CHANGE ORDER TRANSMITTAL LIST

FINAL MILE BIKE FACILITIES

FM No. 446126-1-58-01

Contract G2722

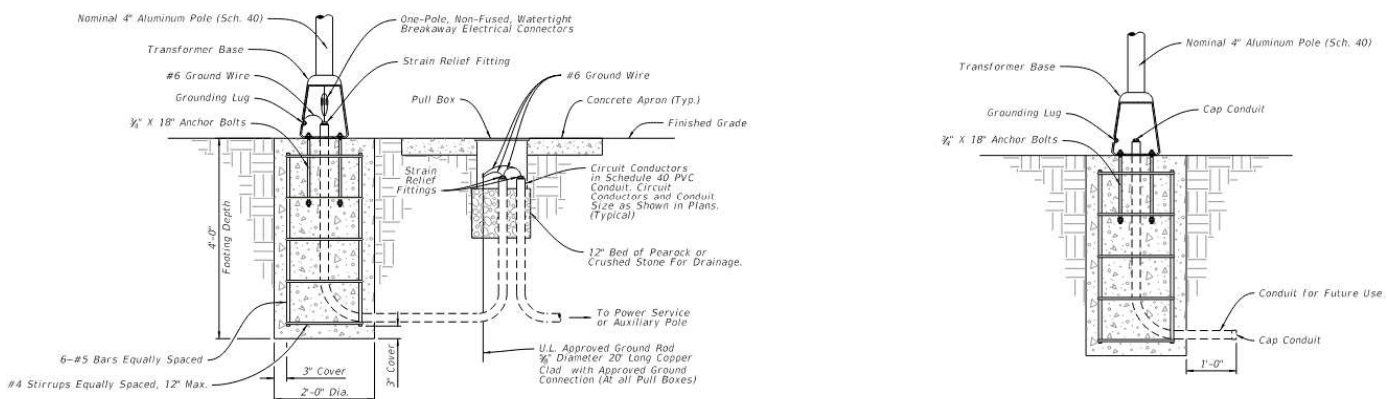
An RFI was sent to the contractor on 4/19/2023 requesting confirmation that the foundation detail in the plans was adequate for the wind loads in Monroe County for the 16 foot long, 4-inch diameter flagging station, pay item 700-12-21 TRANSIT STOP LIGHTING (FLAGGING DEVICE) F&IGROUND MOUNT SOLAR. The original Plan detail required a concrete foundation with a 1-foot by 1-foot non-reinforced concrete square as shown below.

The Engineer of Record response to the RFI was to issue a plan revision that required the foundation to follow the Standard Plans Index 700-120, resulting in the foundation below for the Flagging Station Pay item 700-12-21. See below. As a result, the contractor submitted a request for compensation for the additional concrete, steel reinforcement, transformer base, additional depth and width of drilling, and removal of additional spoils from the site due to increased depths and widths of the foundation. The new foundation requires additional drilling through hard limerock found here in the Keys versus simply drilling a 6-inch diameter hole and forming a 1x1 footing just below the ground surface.

TRANSIT STOP LIGHTING SYSTEM DETAIL (FLAGGING DEVICE)

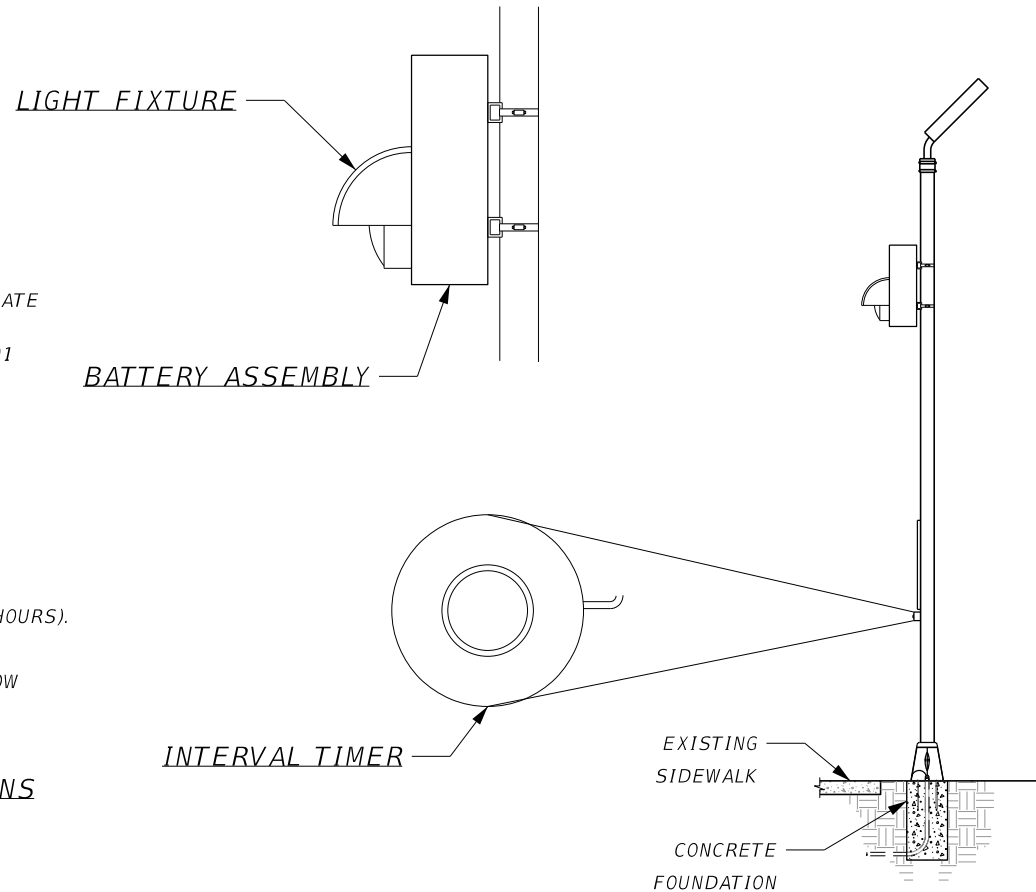
change highlighted by Jacki Hart RS&H for clarification

NOTE: FOR FOUNDATION DETAIL, REFER TO FDOT STANDARD PLAN INDEX 700-120

TRANSIT STOP LIGHTING SYSTEM DETAIL (FLAGGING DEVICE)

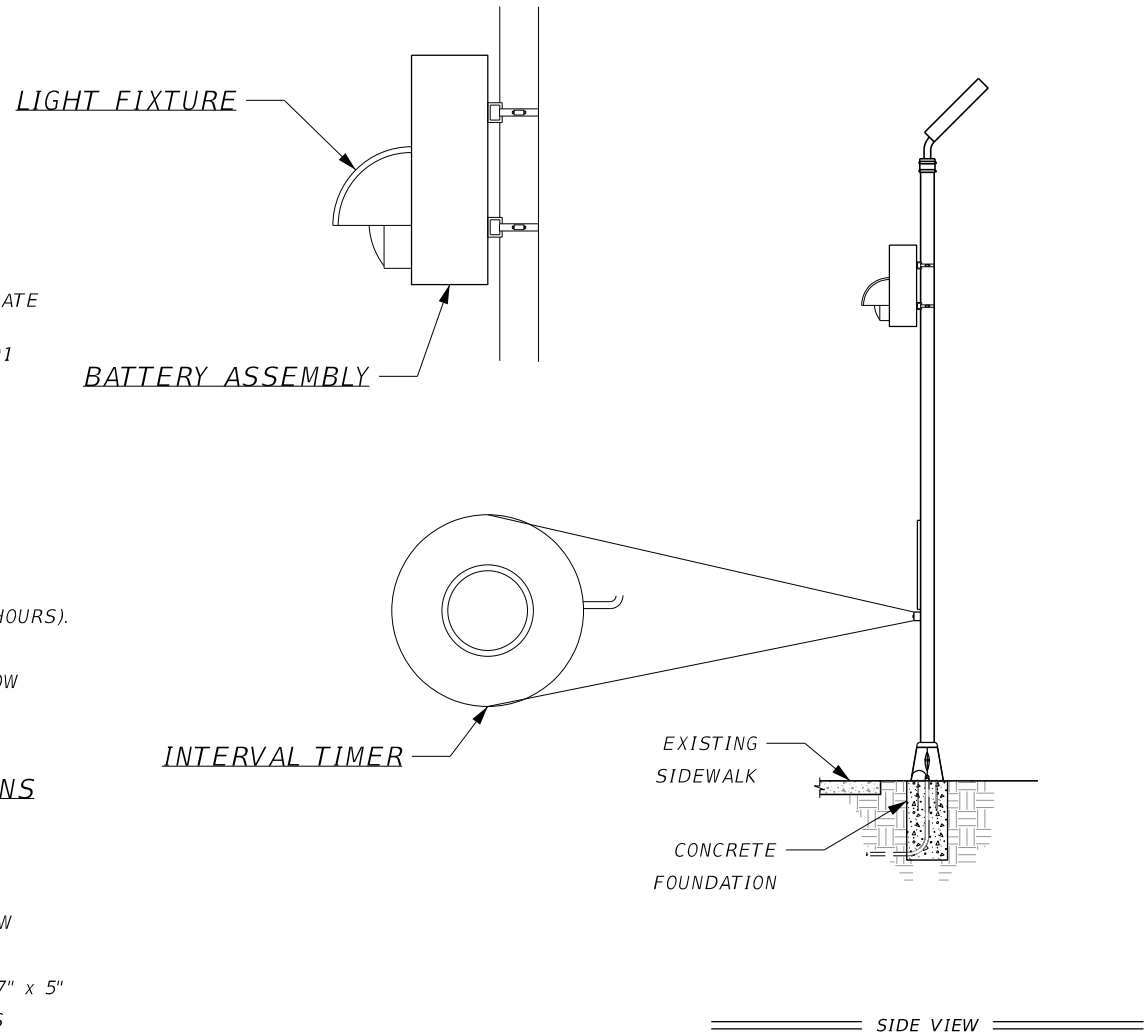
From: Jacki Hart, PE RS&H 17 Ships Way Big Pine Key, FL 33043 email: Jacki.hart@rsandh.com		To: Ryan Stachurski City of Key West email: ryan.stachurski@cityofkeywest-fl.gov Phone: (561) 436 2860	
Project Name: Final Mile Bike Facilities 446126-1-58-01 Contract G2722		Receipt Logged:	
Submitted By: RS&H Jacki Hart, PE	Date: 4/19/2023	DWG/Spec no./Revision/Detail/Sec. No. Plan sheets 52-53 Standard Plans 700-120, PG 1-2	
Subject: Foundation detail/Grounding:payitem 700-120-12 Transit Stop Lighting			
<p>The plans detail a foundation with only 1'x1' of concrete foundation and do not identify the class of concrete or strength. This foundation detail does not meet the required foundation or grounding called for in the FDOT project specifications and the Standard Plans Index 700-120. The pole is specified to be 13 feet above ground and is mounted with a solar panel, light fixture, battery box, and a sign. Generally, even a standard chain link fence here in Monroe county requires 2 feet of concrete for the pole foundation. Prior to installing this pole, I would like to confirm that the foundation is simply 1'x1' concrete and that grounding is not required. I have attached the standard FDOT foundation and the plan sheets for your reference.</p>

Engineering Dept. Review			
Solution: A revised plan sheet was issued by the EOR to follow FDOT Standard Plans.

NOTE: FOR FOUNDATION DETAIL, REFER TO FDOT STANDARD PLAN INDEX 700-120
